## 4A COMMUNICATION SYSTEM

("COM KEY" 416)

### IDENTIFICATION, INSTALLATION, CONNECTION, OPERATION, AND MAINTENANCE CUSTOMER EQUIPMENT

1.001 This addendum supplements Section 518-450-106, Issue 3. Place this pink sheet ahead of Page 1 of the section.

Fig. 9A—Typical Arrangement of Coupled Bonding Conductor

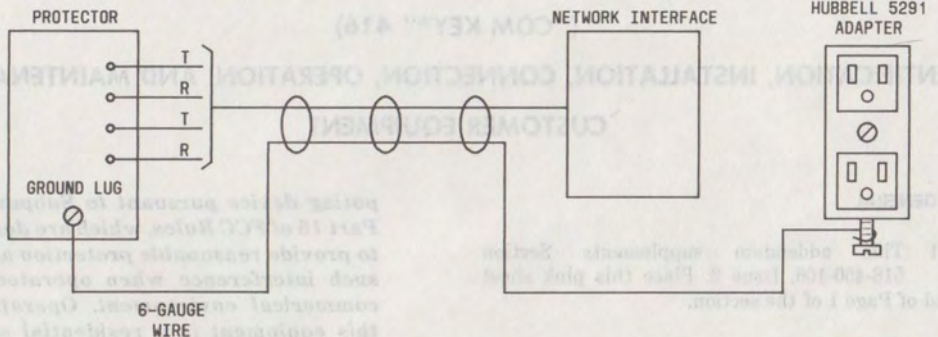
- Put Section 518-450-106 in compliance with the Federal Communications Commission (FCC) ruling which requires that a warning statement be placed in the users documentation for equipment that generates and uses radio frequency energy and may radiate this energy
- Prohibit the use of the 91A connecting block (MD) in all new installations
- Specify size of wire to be used for coupled bonding conductor
- Add Fig. 9A showing method of connecting coupled bonding conductor
- Correct minor typographical errors.

2.006 In paragraph 3.10 on Page 21, add "(Fig. 9A)" at end of first sentence.

2.005 In paragraph 3.09 on Page 21, change second sentence to "This conductor can consist of a shield, spare pairs of the inside wiring cable, or a 6-gauge wire tie-wrapped to unshielded cable."
